### VILLAGE COVERED BRIDGE REHABILITATION - STP EH08 (6)

### BRIDGE STREET STORMWATER IMPROVEMENTS - SSMG 72

## PROPOSED IMPROVEMENT VILLAGE COVERED BRIDGE REHABILITATION AND BRIDGE STREET STORMWATER IMPROVEMENTS

**CONTRACT PLANS  
DECEMBER, 2014**

PLOTTED 9/23/2015

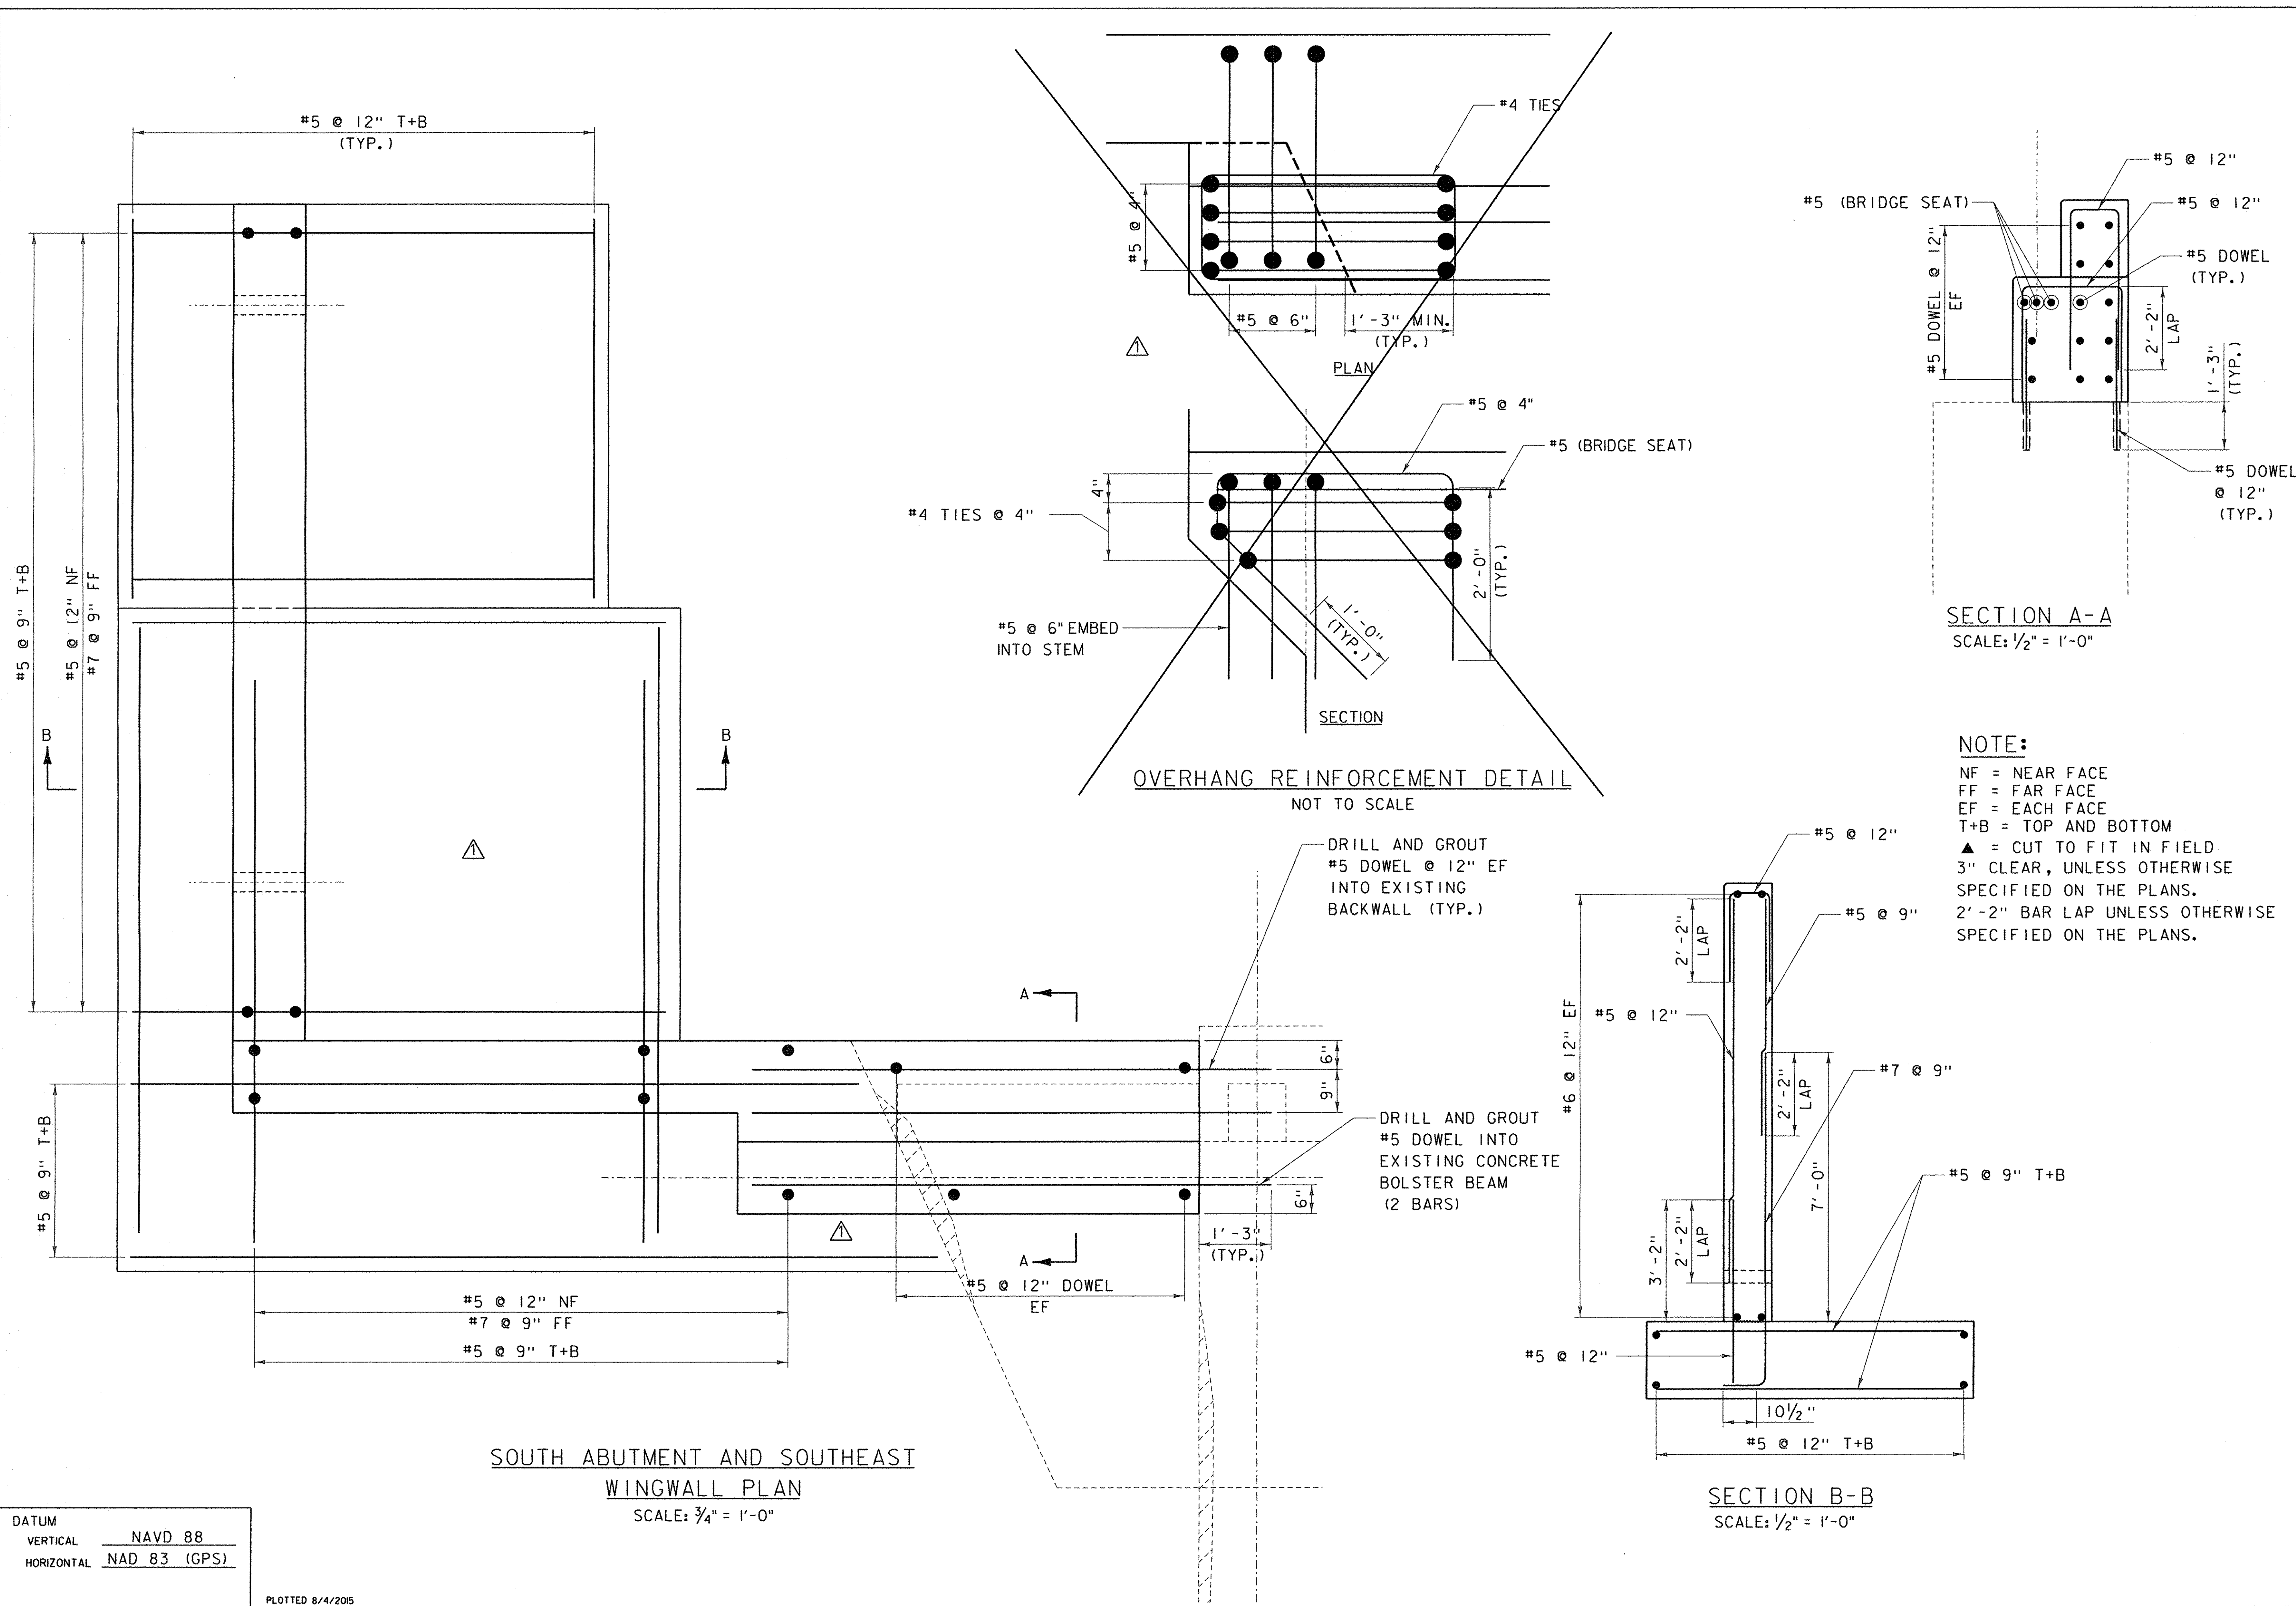
| NO. | DATE    | DESCRIPTION        | BY  | CHKD |
|-----|---------|--------------------|-----|------|
| 1   | 9/22/15 | NEW WALL AND SHEET | PCB | EPD  |

BACKWALL REPLACEMENT DETAIL  
NOT TO SCALE

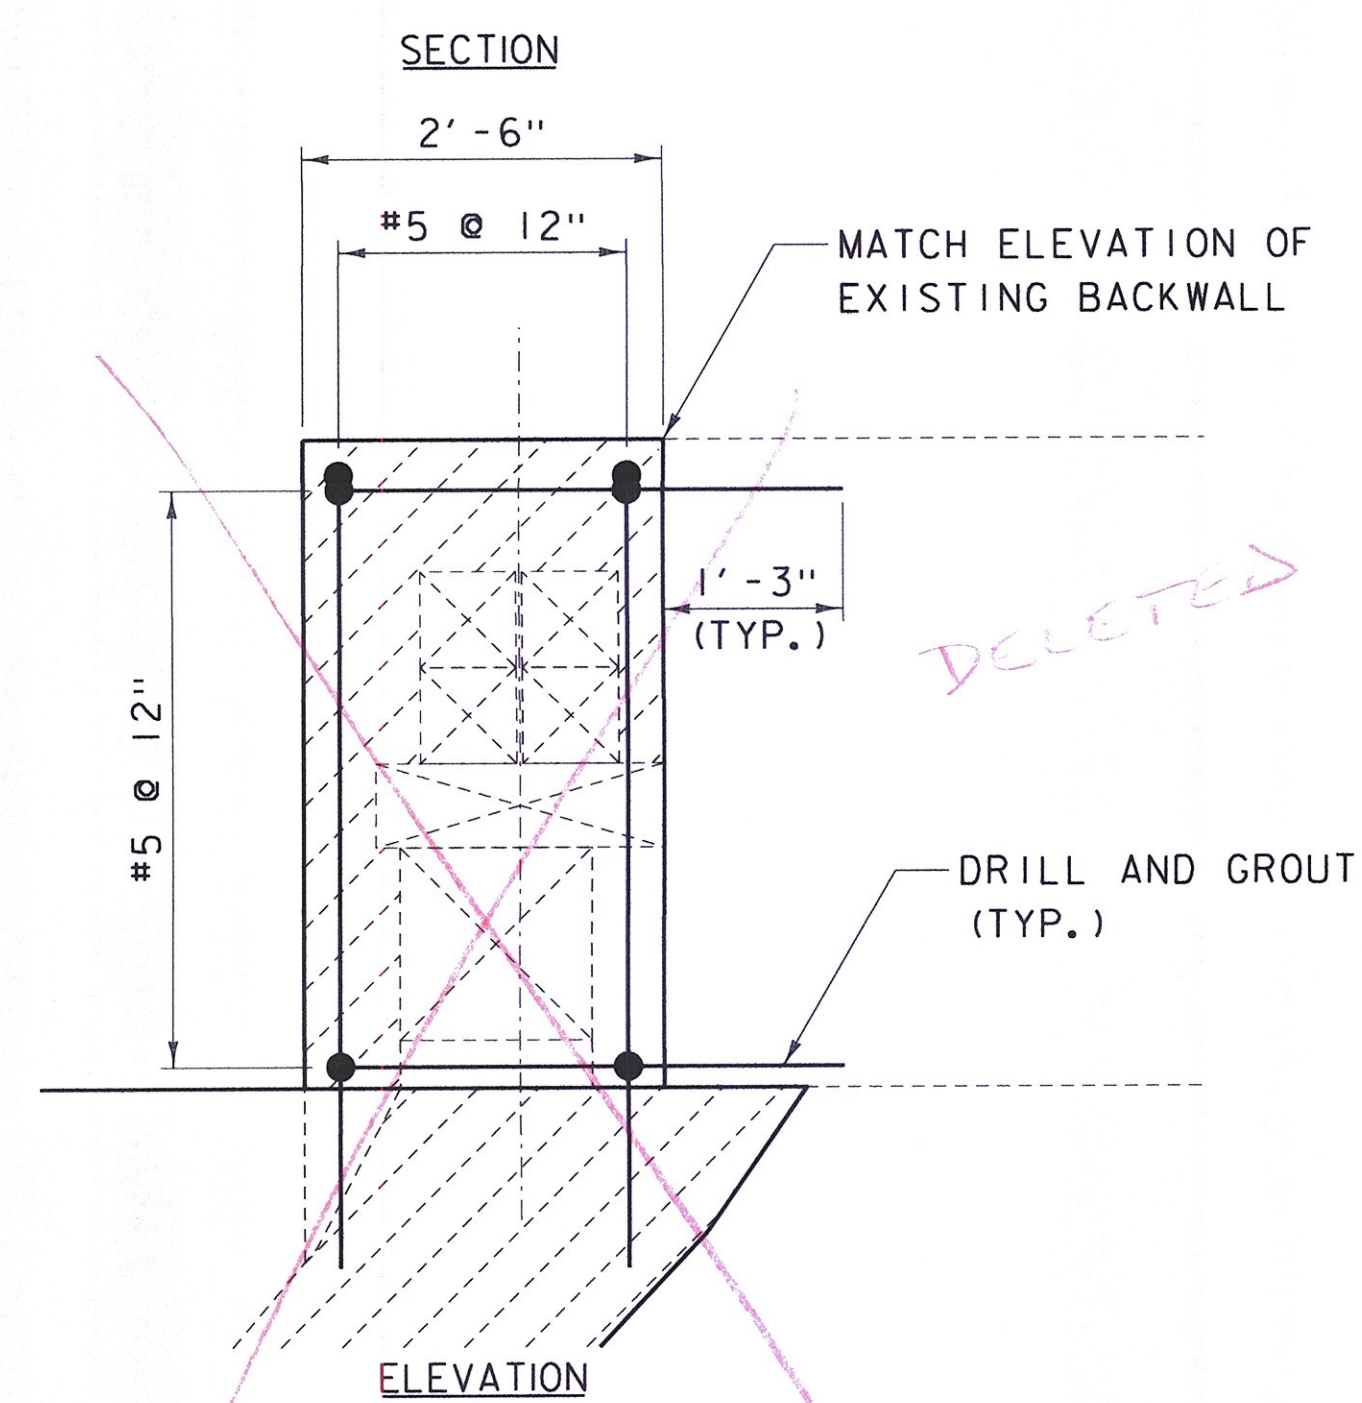
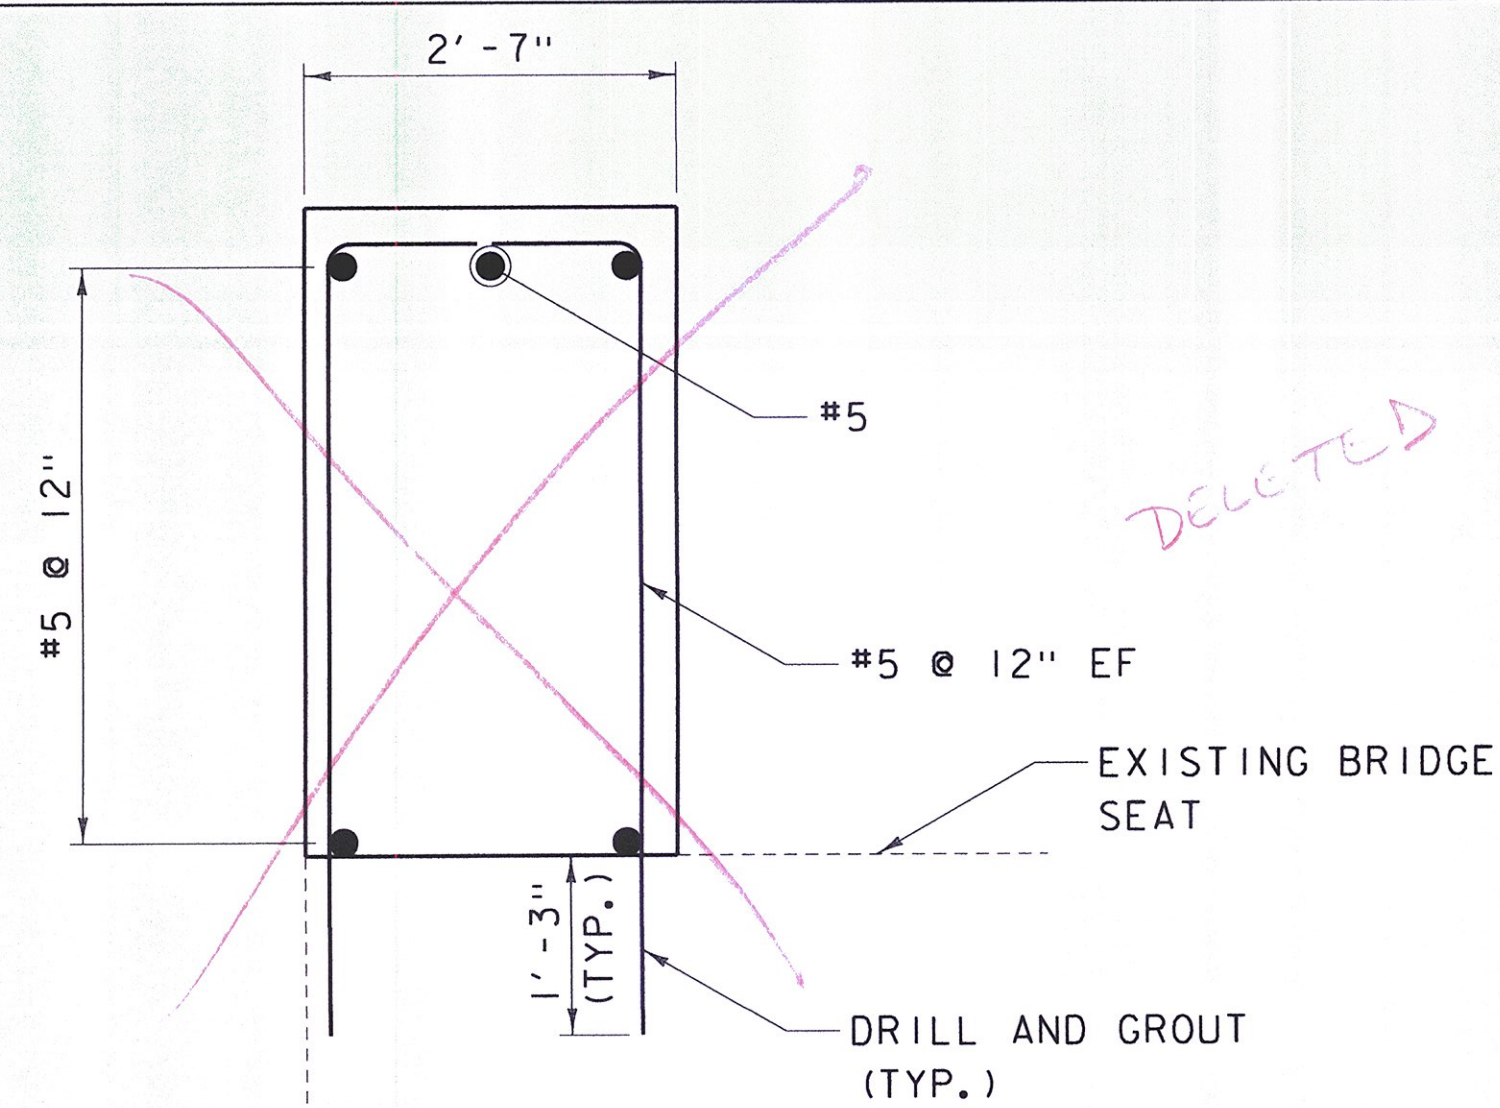
REPAIR w/  
CLASS AA  
CONCRETE
